Town of Hilton Head Island  
**Design Review Board Meeting**  
**Tuesday, December 8, 2020 – 1:15 p.m.**  
**AGENDA**

Town of Hilton Head Island  
**Design Review Board Meeting**  
November 10, 2020 at 1:15 p.m. Virtual Meeting  
**MEETING MINUTES**

## DESIGN TEAM/DRB COMMENT SHEET

**RIGHT SIDE ELEVATION**

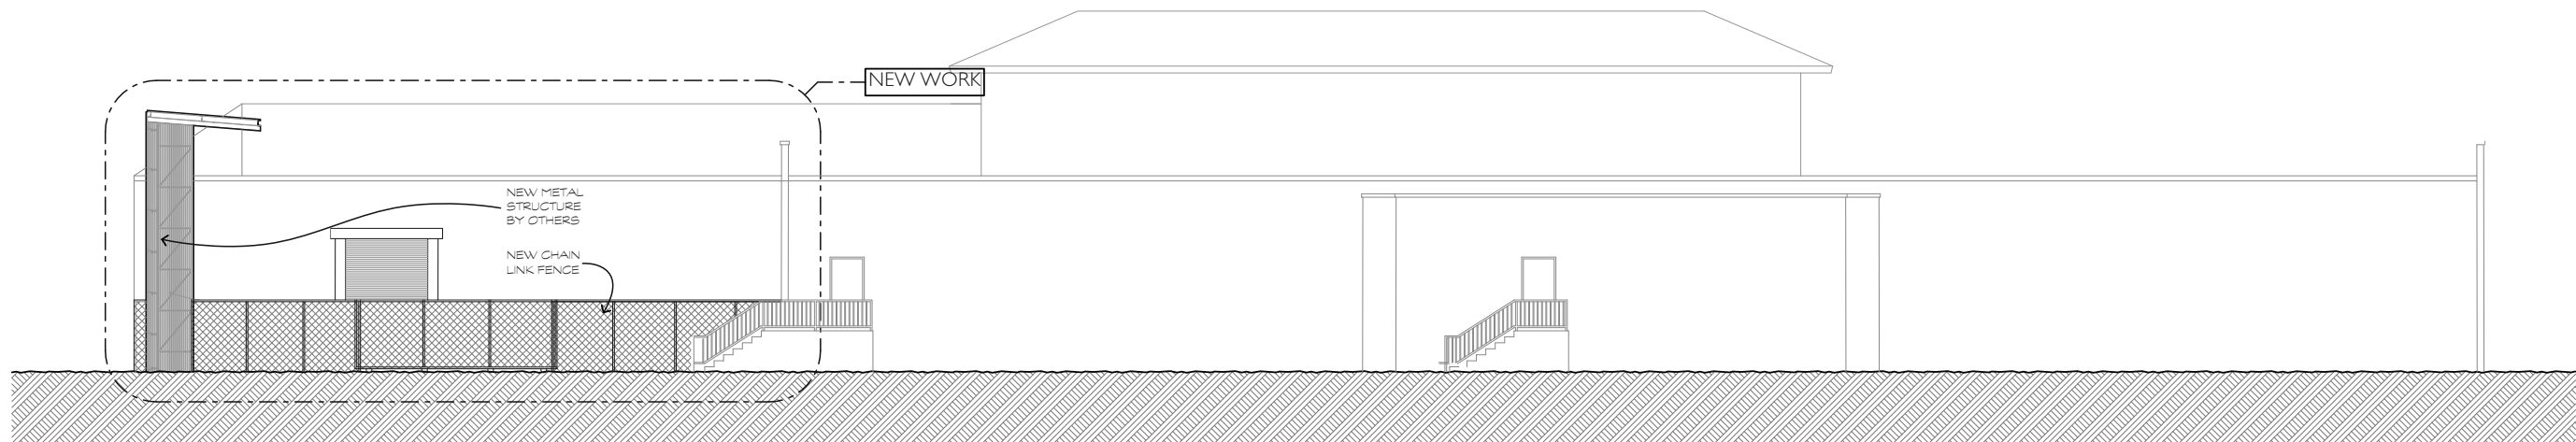
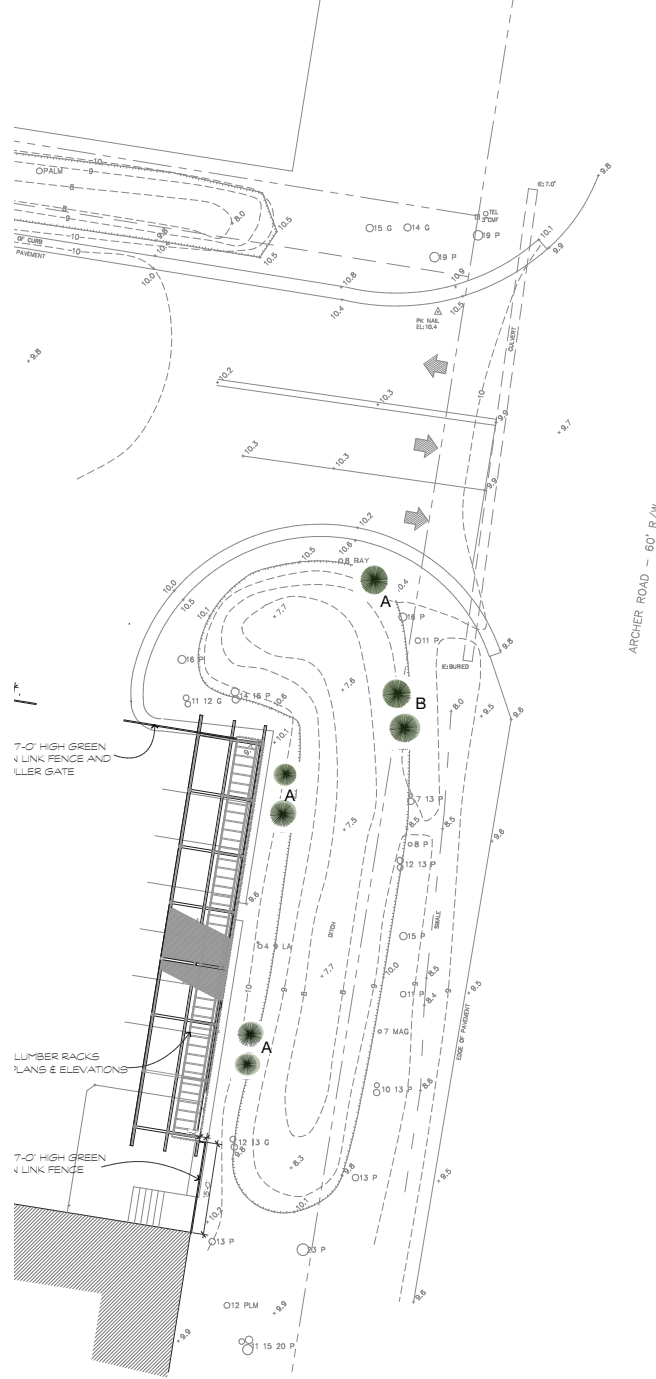
<b><i>ARCHITECTURAL DESIGN</i></b>				
DESIGN GUIDE/LMO CRITERIA	Complies Yes	No	Not Applicable	Comments or Conditions
Structure is designed to be appropriate to the neighborhood	<input type="checkbox"/>	<input checked="" type="checkbox"/>	<input type="checkbox"/>	While there are metal sided building in the immediate area, per the Design Guide, page 15, "Single material facades are generally not appropriate."
Avoids monotonous planes or unrelieved repetition	<input type="checkbox"/>	<input checked="" type="checkbox"/>	<input type="checkbox"/>	Per the Design Guide, page 15, "Single material facades are generally not appropriate."
Has a strong roof form with enough variety to provide visual interest	<input type="checkbox"/>	<input checked="" type="checkbox"/>	<input type="checkbox"/>	See the Design Guide, page 15, "Form". "Roof form is also a key element to achieve Island Character."
Overhangs are sufficient for the façade height.	<input type="checkbox"/>	<input checked="" type="checkbox"/>	<input type="checkbox"/>	The addition of an overhand on the Archer Road elevation with a stepper slope on the roof toward Archer Road would give the structure more "Island Character". Per the Design Guide, page 13, "Overhangs of sufficient depth and in proportion to the façade height can also be important to roof form and for shadow play."

wood simulating material is strongly encouraged.”
Decorative lighting is limited and low wattage and adds to the visual character	<input type="checkbox"/>	<input checked="" type="checkbox"/>	<input type="checkbox"/>	Indicate on the plans, “No additional lighting is proposed.”
Accessory elements are design to coordinate with the primary structure	<input type="checkbox"/>	<input checked="" type="checkbox"/>	<input type="checkbox"/>	The proposed structure does not relate to the existing building.

**PIGGLY WIGGLY FACADE IMPROVEMENTS**

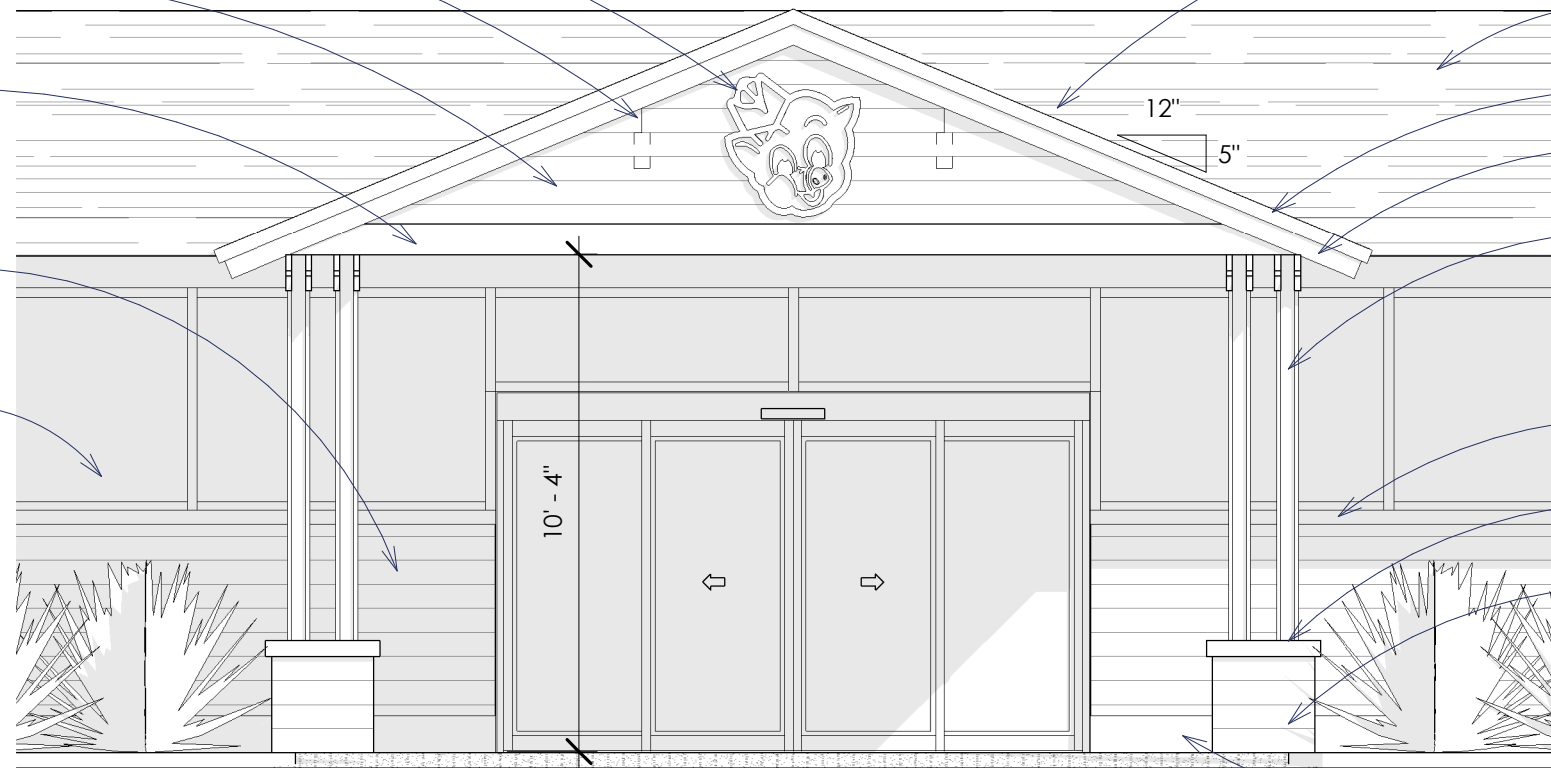
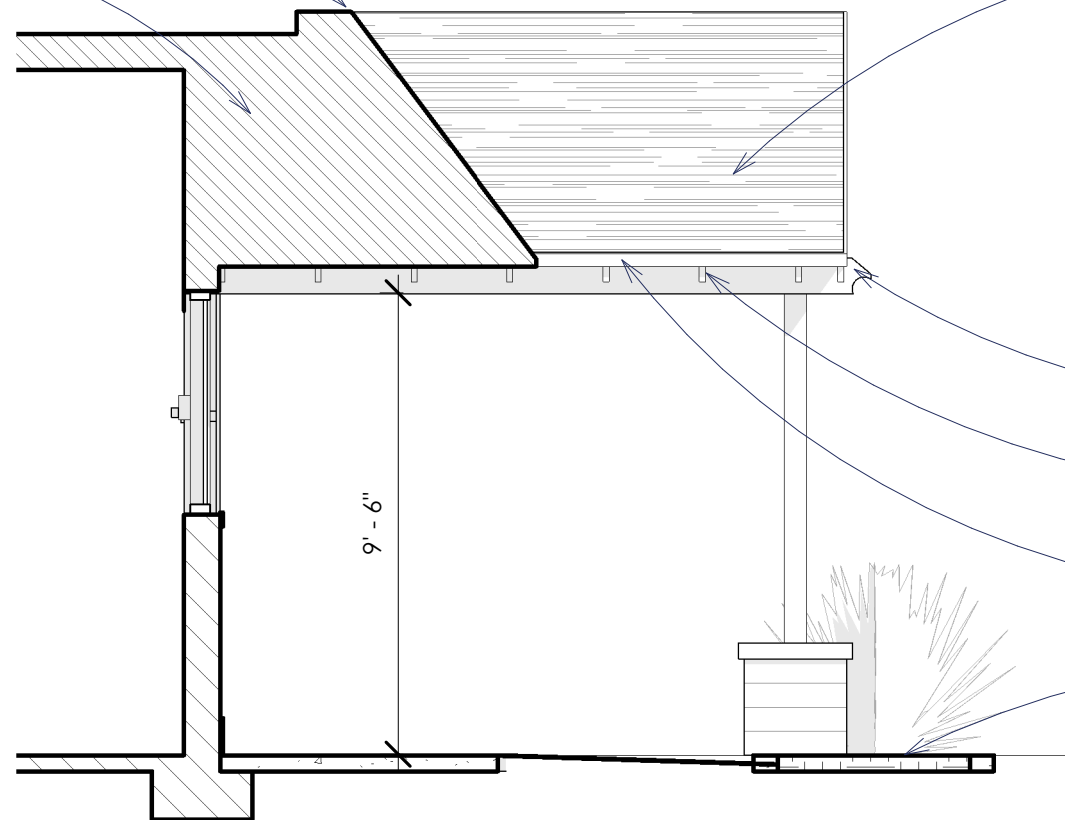
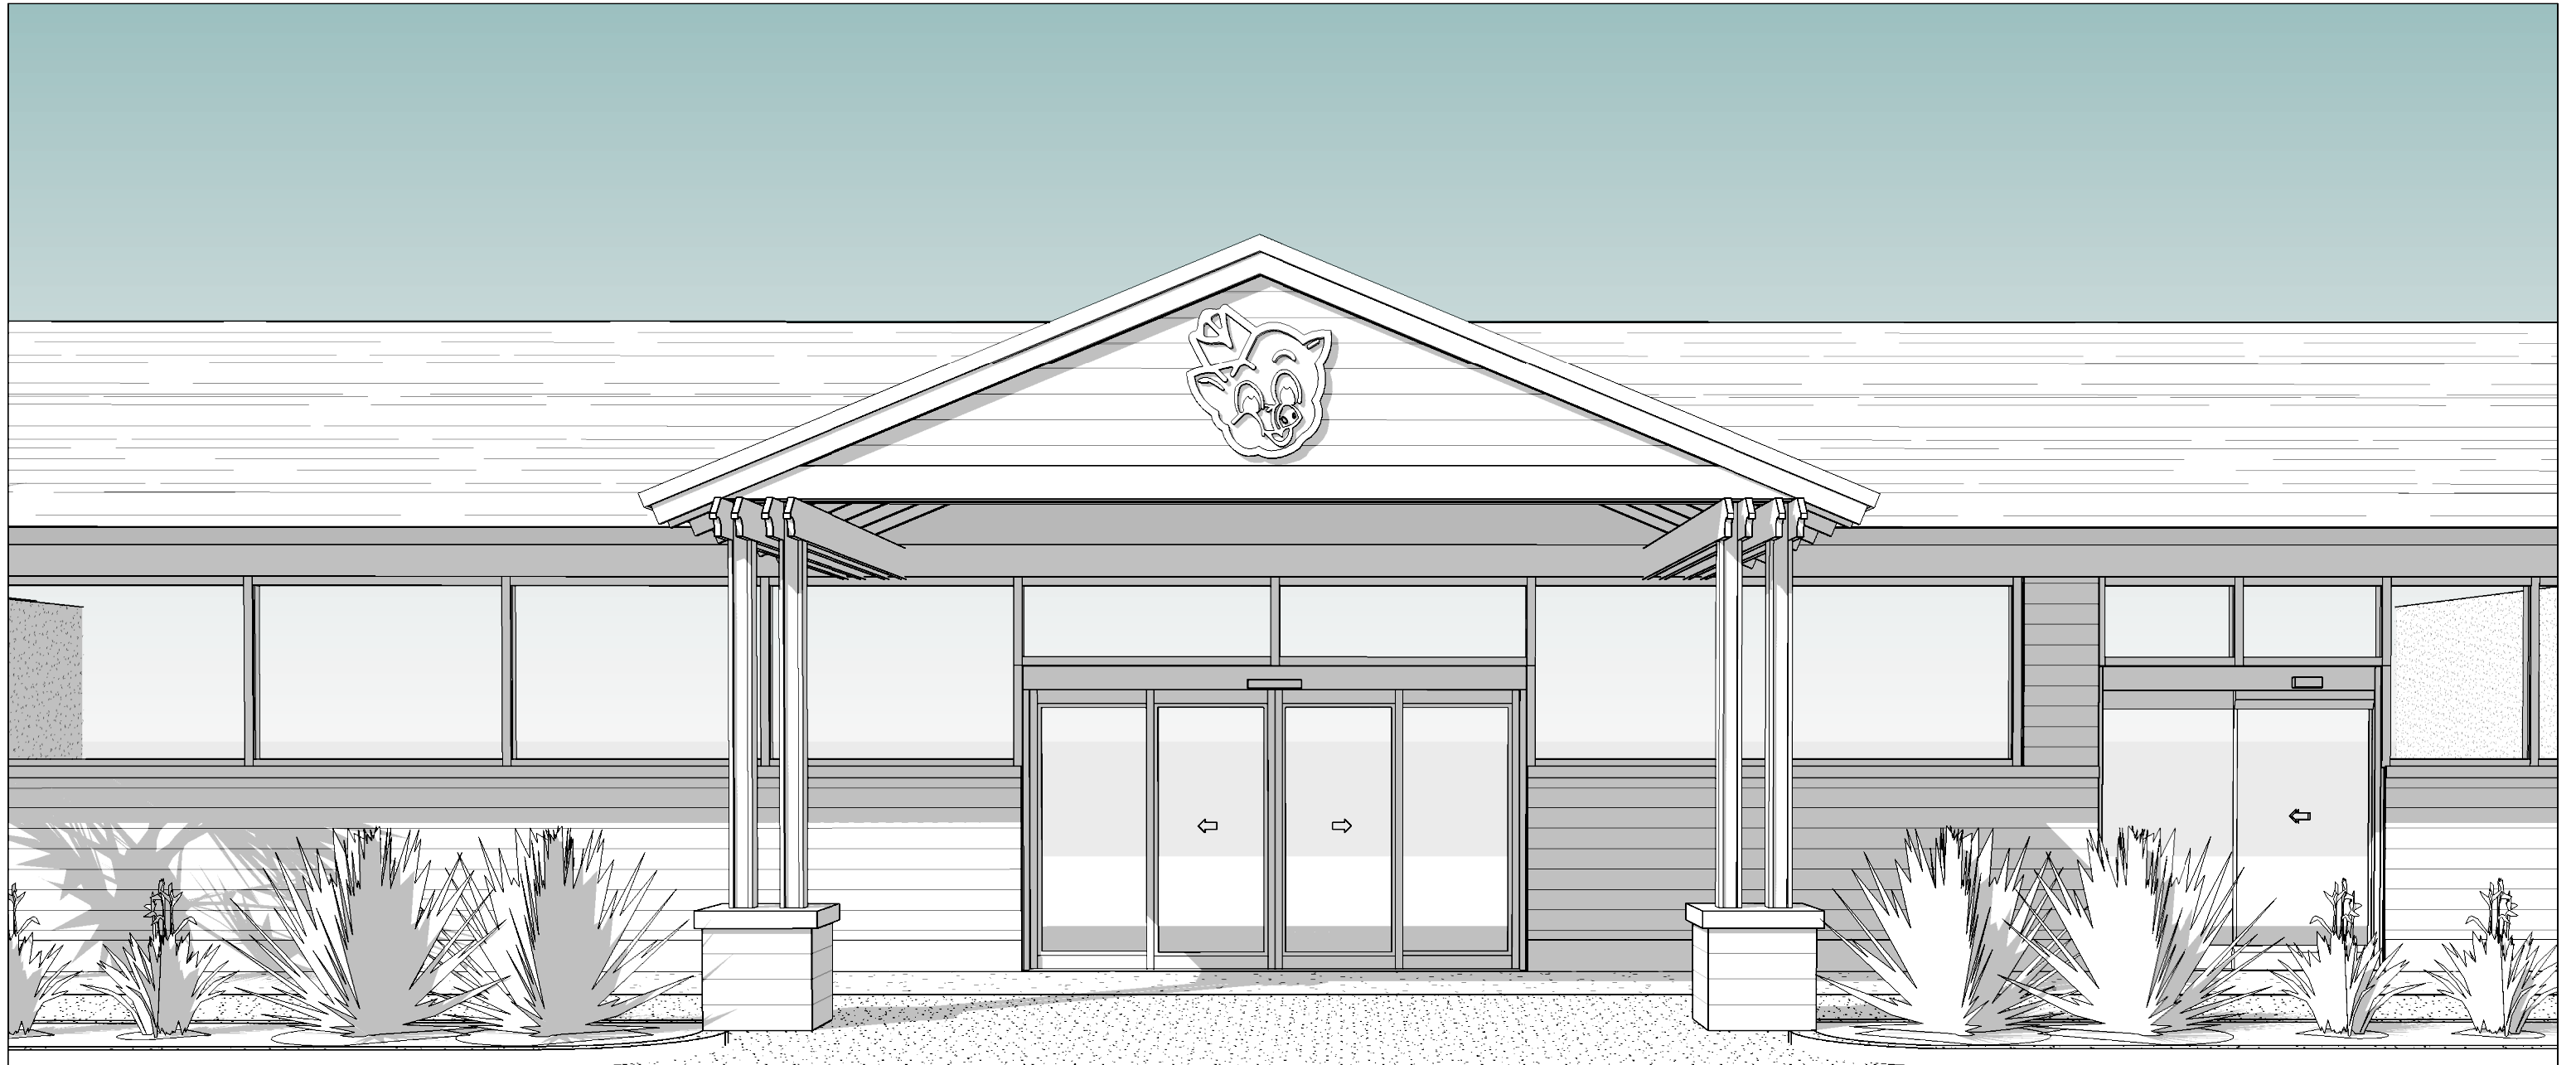
<b><i>MISC COMMENTS/QUESTIONS</i></b>
The awning is proposed over one door only, which currently functions as the exit. Will the other entrance be abandoned? Consideration should be given to a different style of entry feature that could extend over both doors, with a planting island in between. Gutters should be considered.
Clarification is needed on the proposed connection to the building. The drawings indicate a header above the windows, but this could not be confirmed in the field. The ceiling appears to meet the top of the windows.
The existing metal roof wraps around on both sides of the building. This should all be replaced or additional information should be provided on the location and transition between materials.
All locations proposed for white paint should be changed to Coligny beige.

The landscape plan should be revised to show a double staggered row of Pink Muhly Grass. Staff suggests replacing both the Pink Muhly Grass and the Pampas Grass with Fakahatchee Grass or mixture of other evergreen plants.
